November 10, 2025

Re: Comprehensive Permit for Preliminary Plan Review – Village at Tiogue located at Tiogue Ave., and Tiffany Rd., Assessor’s Plat 32, Lots 149, 150, 151, and 153 (“Property”)

EXHIBIT 1

**RE: Request for Modified Monumentation Plan
Village at Tiogue – Assessor's Map 32 Lots 149, 150, 151, & 153
Project #: 0267-132**

YIELD PLAN

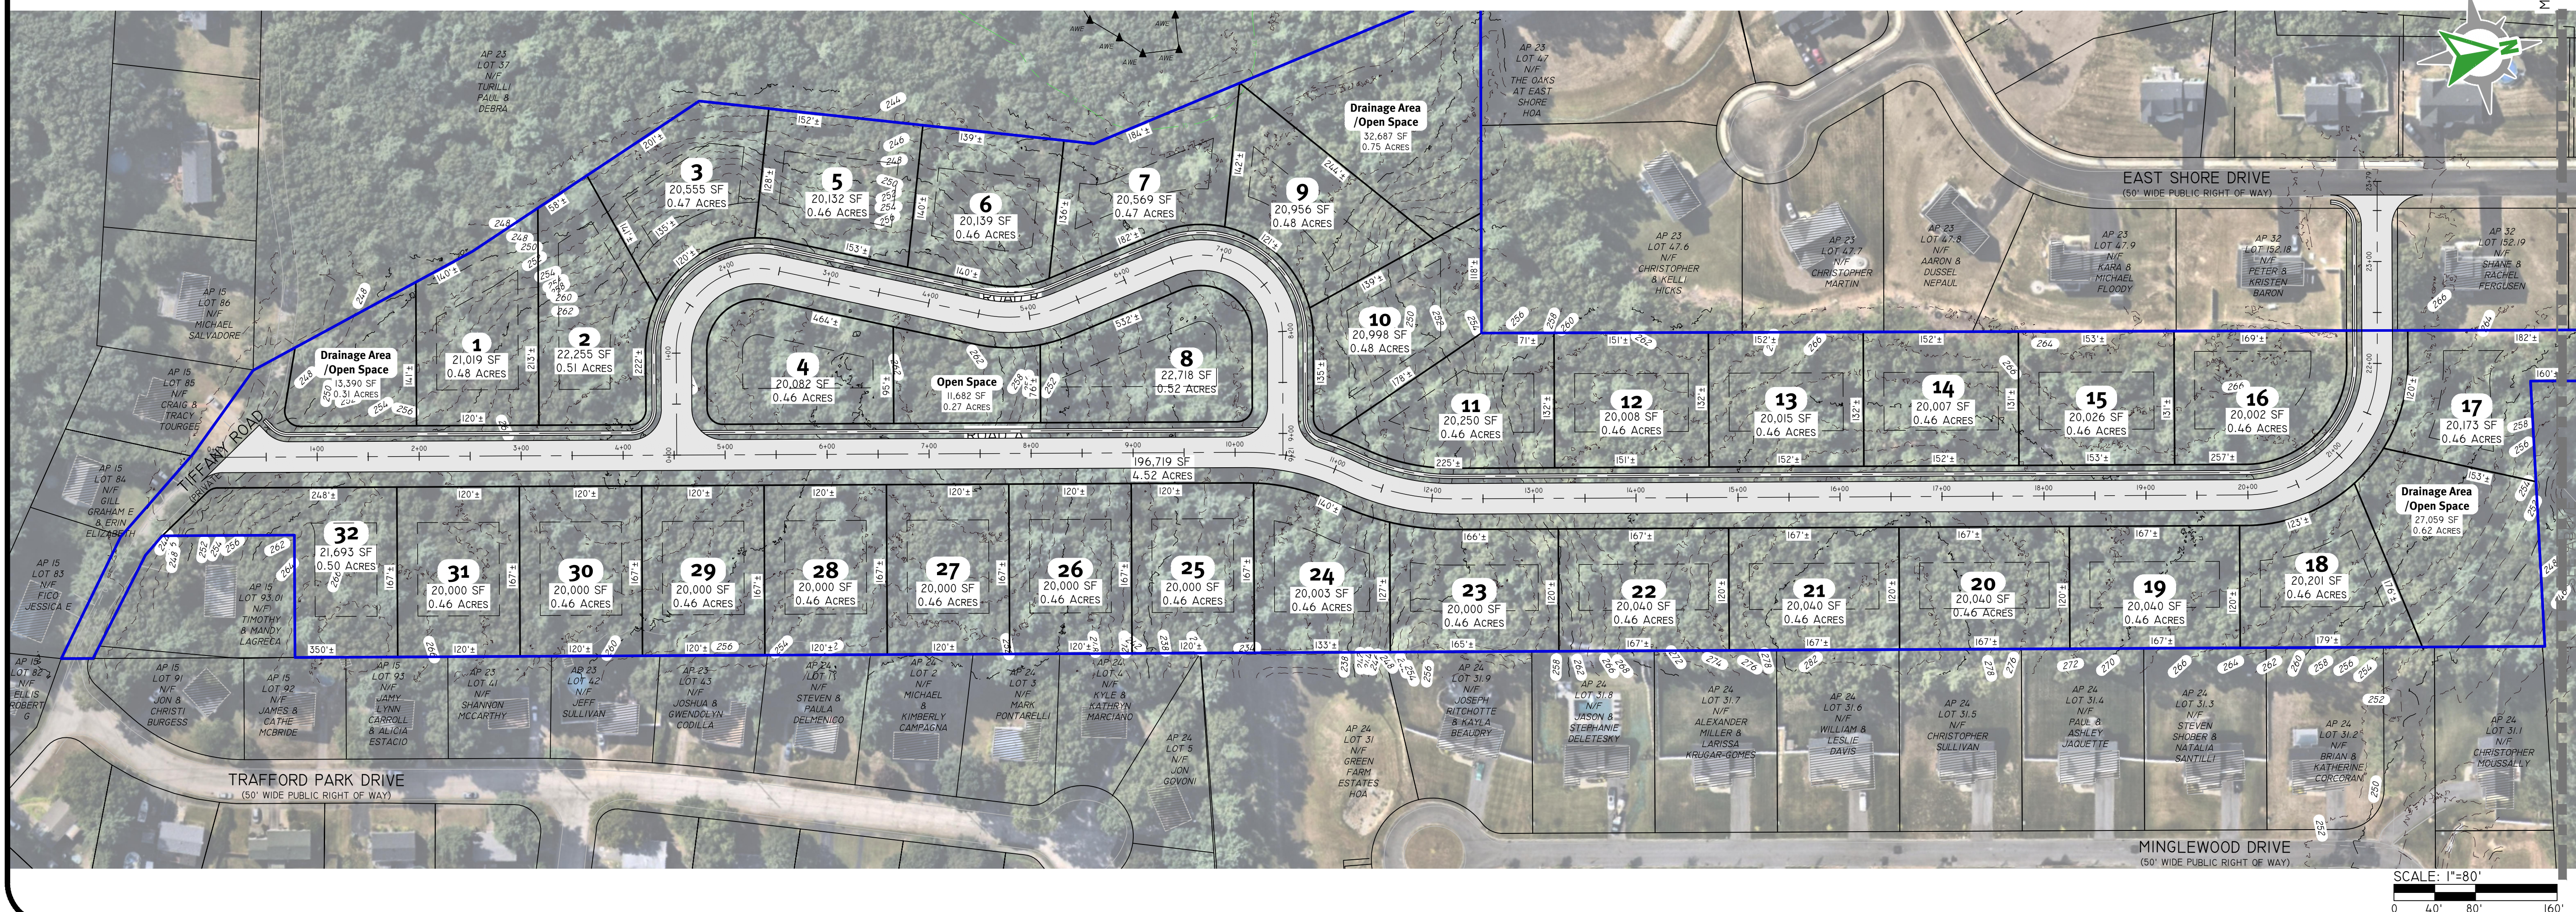
Comments 1-5 of the “Principal Planner Designee” section in the TRC report discusses the density analysis under R.I. Gen. Laws §45-53-4, with a suggestion that the yield plan provided is not accurate and does not “appear to meet the minimum zoning and subdivision requirements for the subject property.” The yield plan provided is accurate. R.I. Gen. Laws §45-53-4 provides that a municipality shall provided an applicant with more dwelling units than allowed by right under its zoning ordinance. ...” The yield plan provided complies with all zoning requirements for lot size, frontage and other dimensional standards applicable to the underlying zone. The determination of yield is made only with reference to the provisions of the zoning ordinance.

Nevertheless, we have made every effort to adhere to best design practices and conformance with the subdivision and land development regulations (though not required) for this plan, including the inclusion of a 60’ right-of-way and associated stormwater areas. The updated yield plan is attached hereto as **Exhibit 3** and confirms the 39-unit base density set forth in the Narrative analysis with the original submission.
